**SUBDIVISION,
PLANNED UNIT DEVELOPMENT, &
REZONING STAFF REPORT**

Date: January 19, 2017

<u>APPLICANT NAME</u>	Fred Straub (NVP Management LLC)
<u>SUBDIVISION NAME</u>	Bishop Lane Subdivision
<u>DEVELOPMENT NAME</u>	Bishop Lane Subdivision
<u>LOCATION</u>	3 and 5 Bishops Lane (Northeast corner of Bishops Lane and Zimlich Avenue)
<u>CITY COUNCIL DISTRICT</u>	Council District 7
<u>PRESENT ZONING</u>	R-1, Single-Family Residential District
<u>PROPOSED ZONING</u>	R-1, Single-Family Residential District & LB-2, Limited Business District
<u>AREA OF PROPERTY</u>	4 Lots/1.1± Acre
<u>CONTEMPLATED USE</u>	Subdivision Approval to create four legal lots of record from four legal lots of record; Planned Unit Development to allow reduced lot sizes and setbacks; and Rezoning from R-1, Single-Family Residential District to R-1, Single-Family Residential District and LB-2, Limited Business District to allow a proposed office space. It should be noted, however, that any use permitted in the proposed district would be allowed at this location if the zoning is changed. Furthermore, the Planning Commission may consider zoning classifications other than that sought by the applicant for this property.

SITE PLAN

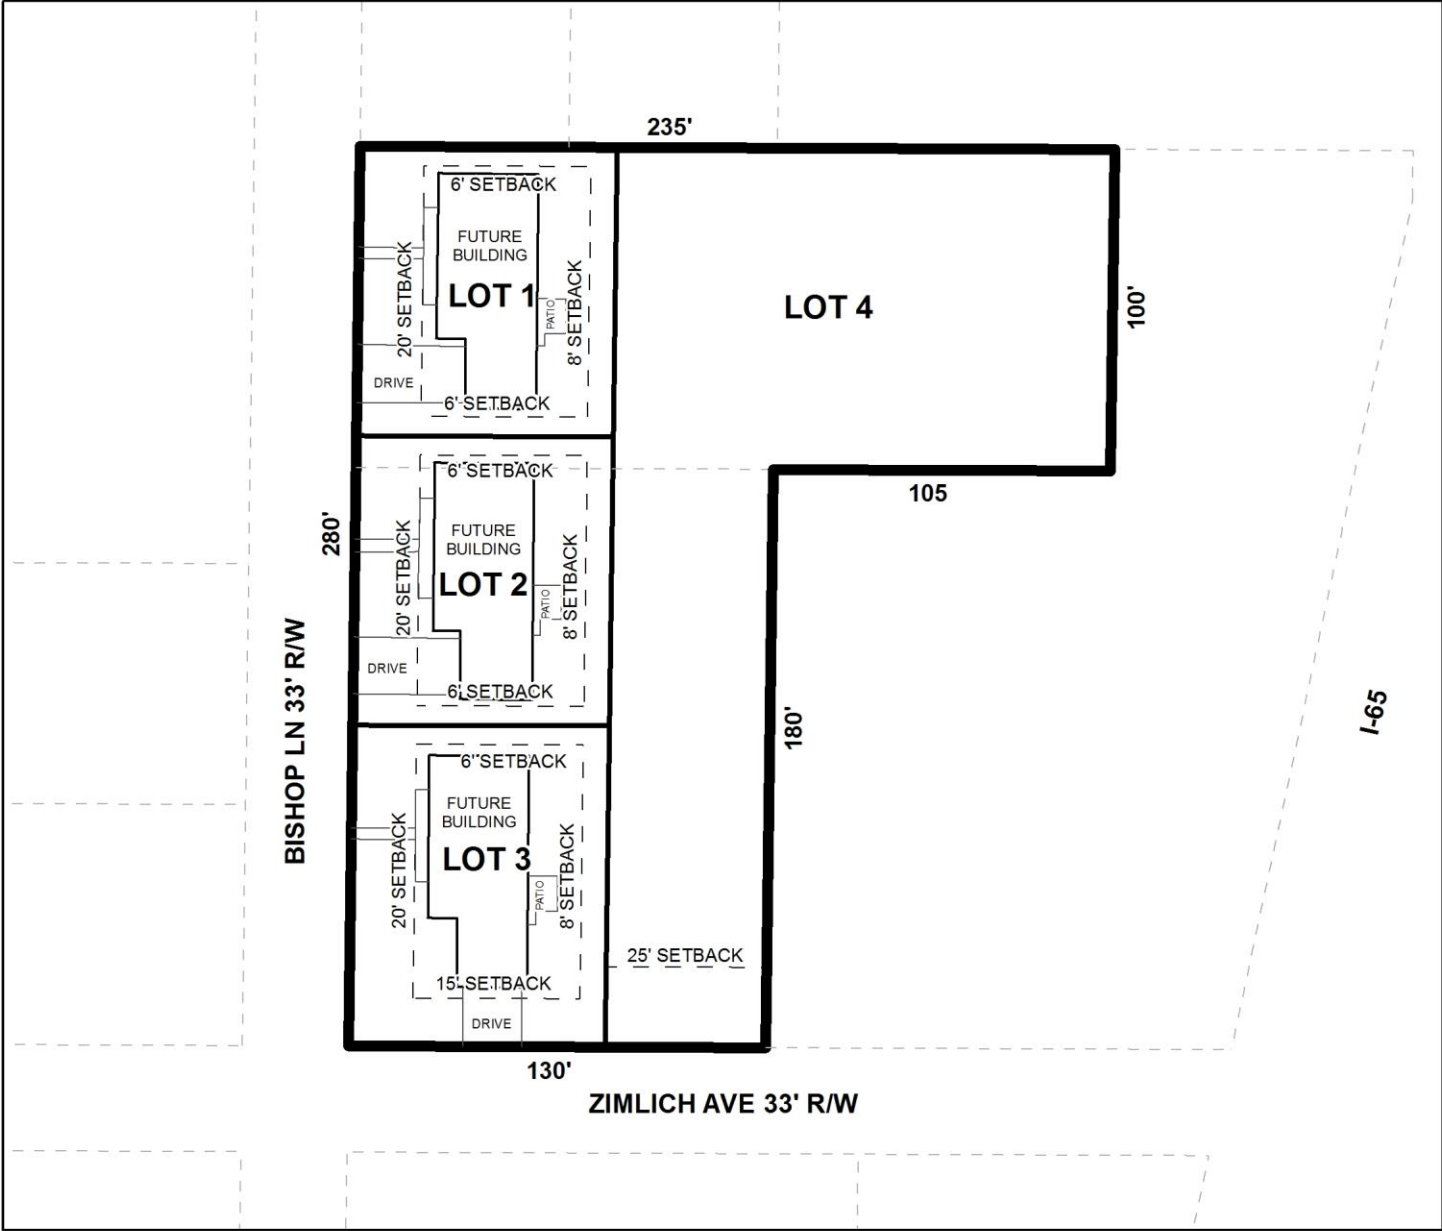
The site plan submitted for the proposed office building shows illustrates a 2,400 square foot building, and 9 parking spaces, however the site plan incorrectly states that 8 parking spaces are proposed (8 are required). The site plan does illustrate frontage trees, but does not provide calculations for staff to determine if full compliance with landscape area and tree plantings will be provided. If approved, the site plan should be revised to illustrate full compliance with landscape area and tree planting requirements.

A dumpster is not illustrated on the site plan, nor is there a note stating that curbside pickup will be utilized. If approved, either a dumpster with sanitary sewer connection and compliant screening should be provided, or a note stating that curbside pickup will be used should be illustrated on the site plan.

The site plan submitted illustrates a 6' high wooden privacy fence adjacent to the properties proposed to remain R-1, however, it should be noted that the fence should not exceed 3' in height within the front 25' setback. If approved, the site plan should be revised to illustrate that the fence will comply with this requirement.

It should also be noted that the proposed side yard setbacks for the residential lots are less than 8' where they abut property outside of the proposed Planned Unit Development, and typically the

Planning Commission requires a minimum 8' side yard setback where a PUD abuts properties outside of the development.

SITE PLAN

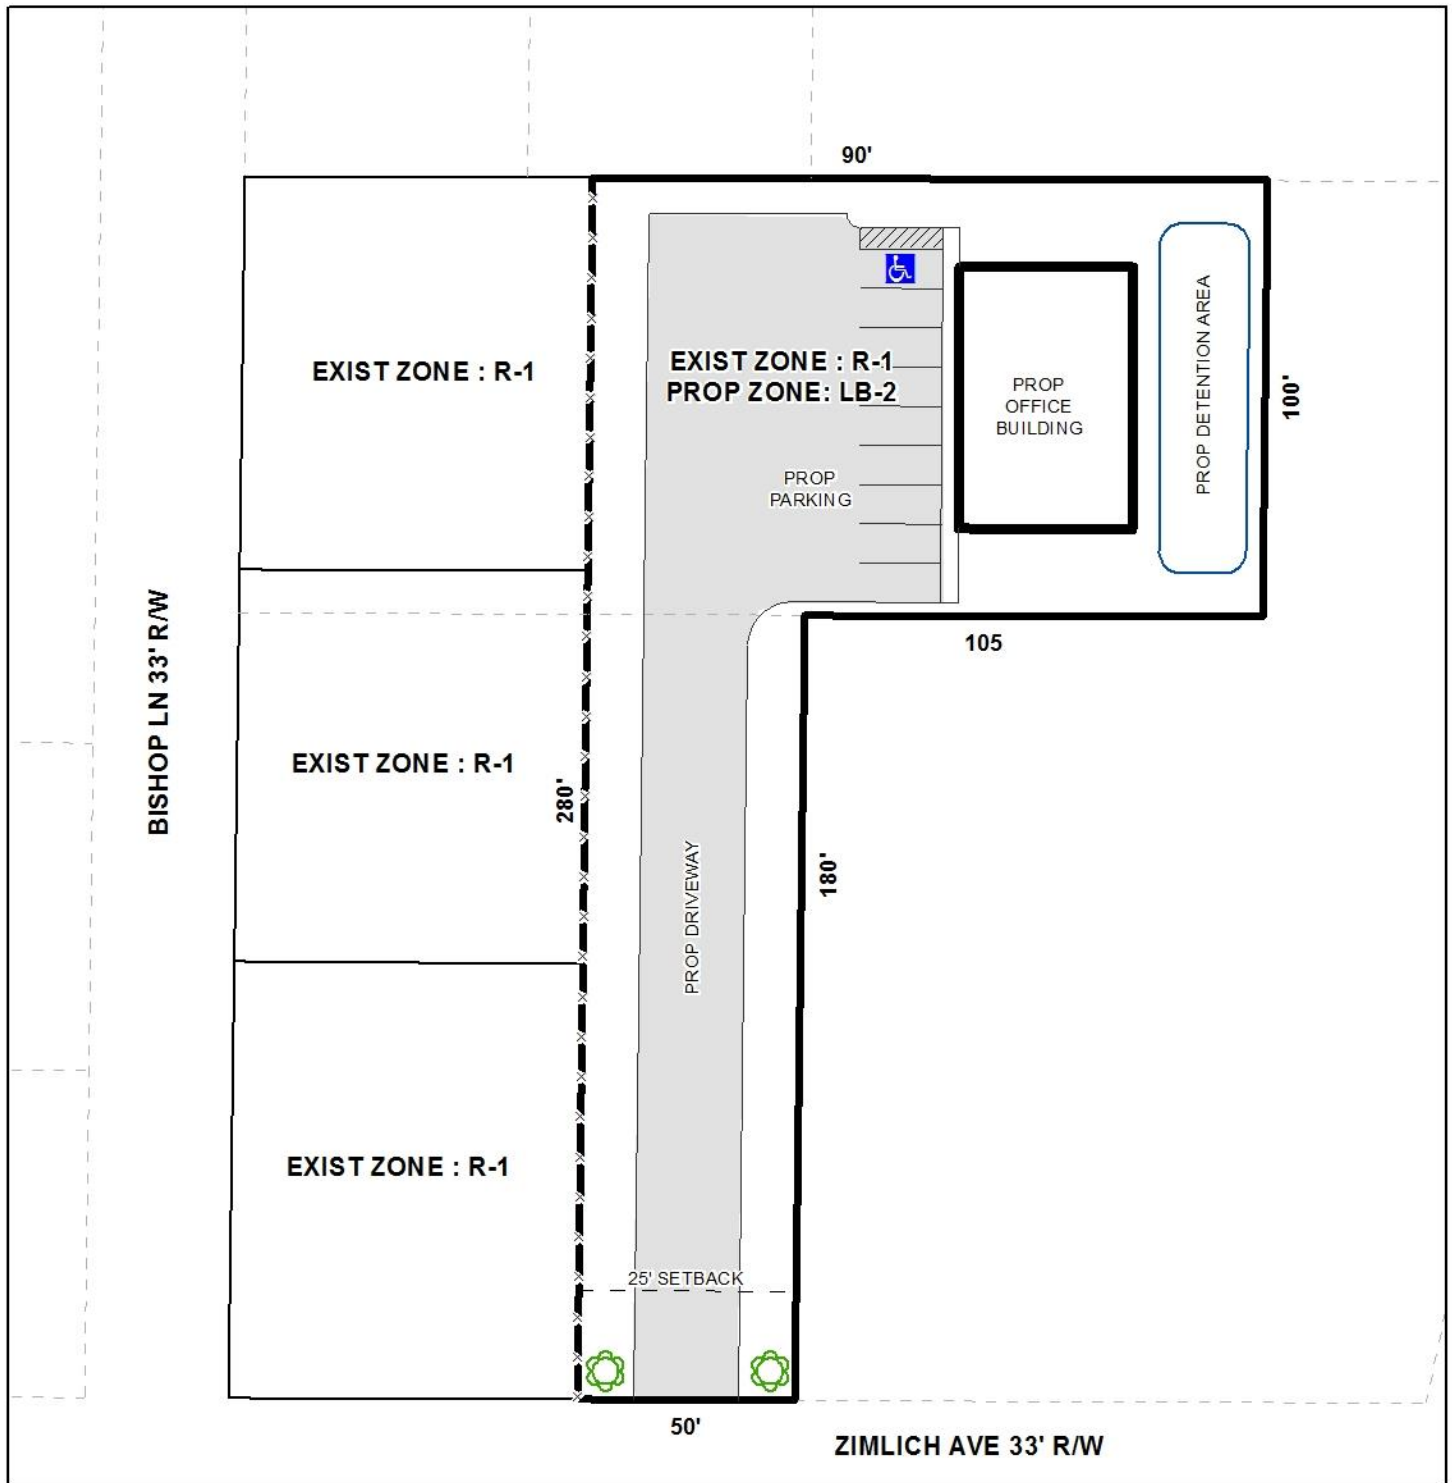
- C. One drawing submitted is labeled RESUBDIVISION OF LOTS 12 & 13 FOREST SUBDIVISION and one is labeled BISHOP LANE SUBDIVISION. Please clarify which is the PRELIMINARY PLAT and which is the PUD SITE PLAN.

- 1. One drawing submitted is labeled RESUBDIVISION OF LOTS 12 & 13 FOREST SUBDIVISION and one is labeled BISHOP LANE SUBDIVISION. Please clarify which is the PRELIMINARY PLAT and which is the PUD SITE PLAN.
- 2. Due to the proposed subdivision, the proposed lots will need to be assigned a different 911 address. Please contact the Engineering Department (208-6216) to discuss the options.

Each lot is limited to one curb cut, with size, location and design to be approved by Traffic Engineering and conform to AASHTO standards. Any required on-site parking, including ADA handicap spaces, shall meet the minimum standards as defined in Section 64-6 of the City’s Zoning Ordinance. Lot 4 as proposed with 50’ of frontage is substandard when considering the City commercial driveway standards (24’ width plus 20’ radii).

The proposed lots, as depicted, meet the minimum size of 7,200 square feet as regulated by the Subdivision Regulations. However, due to required dedication along both frontages, the three residential lots along Bishops Lane will be reduced below the minimum size (Lot 1: 6,350± square feet, Lot 2: 6,350± square feet, and Lot 3: 5,742.25± square feet) hence the Planned Unit Development request. Also as part of the PUD request, the applicant wishes these lots to have reduced front and side yard setbacks. The proposed commercial lot is proposed to have standard setbacks.

The proposed setbacks for Lots 1 and 2 are: 20' for the front, 6' on each side yard (for a combined side yard setback of 12'), and 8' for the rear. The standard Zoning Ordinance required setbacks for Lots 1 and 2 are 25' for the front, 8' minimum side yard setback (with a minimum combined side yard setback of 20'), and 8' for the rear. The proposed setbacks for Lot 3 are 20' for the front, 6' on the left side yard, 15' from the side street side yard (for a combined side yard setback of 21'), and 8' for the rear. The standard Zoning Ordinance required setbacks for Lot 3 are 25' for the front, 8' minimum side yard setback, 20' side street side yard setback (for a combined minimum side yard setback of 28'), and 8' for the rear. It should be noted that the required dedication along both frontages will impact the proposed setbacks. The applicant states in their narrative that they are aware that required dedication will reduce the lots below the minimum required lot size of Section V.D.2. of the Subdivision Regulations, but did not

illustrate the proposed dedication on the preliminary plat, nor the impact on the proposed setbacks.
